A.C. Wright Design		
Sheet: /		
File: ACE_RAM_Patch.kicad_sch		
Title: AC6502 ACE RAM Patch		
Size: A4	Date: 2026-09-24	**Rev: 1.1**
KiCad E.D.A. 10.0.3		Id: 1/1

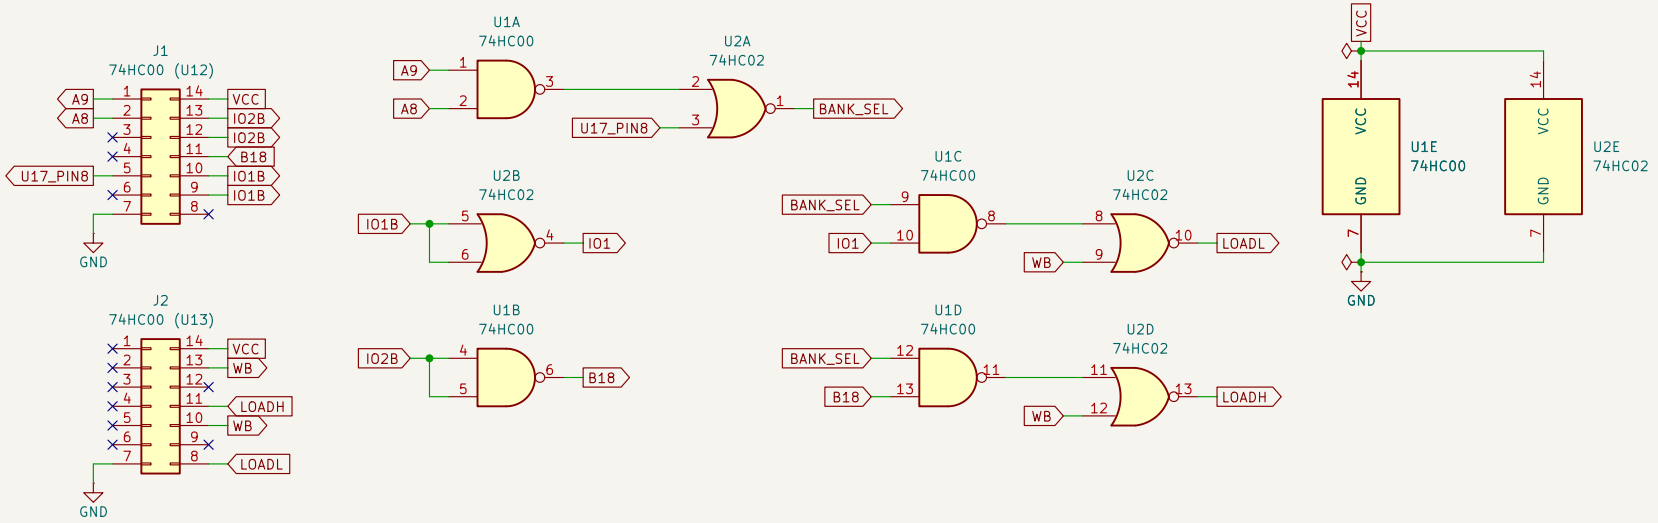
Fitting: take U12 and U13, chips and sockets, off the Rev 1.0 ACE Board. The patch mounts underneath it, front side up: pin headers from J1 go into U12's holes and from J2 into U13's, soldered on both boards. U1 and U2 are on the back, hanging below; trim their leads flush on the front. U13's pin 1 is 23.00 mm from U12's along the row, so J2 sits 23.00 mm from J1.

LOADL and LOADH go high only on a write to the bank register, $83FF or $87FF, while PHI2 is high: A9·A8·(A0–A7 all ones), with IO1 for LOADL and B18 for LOADH, and /WB. U17_PIN8 is the 74HC30's output, /(A0–A7).
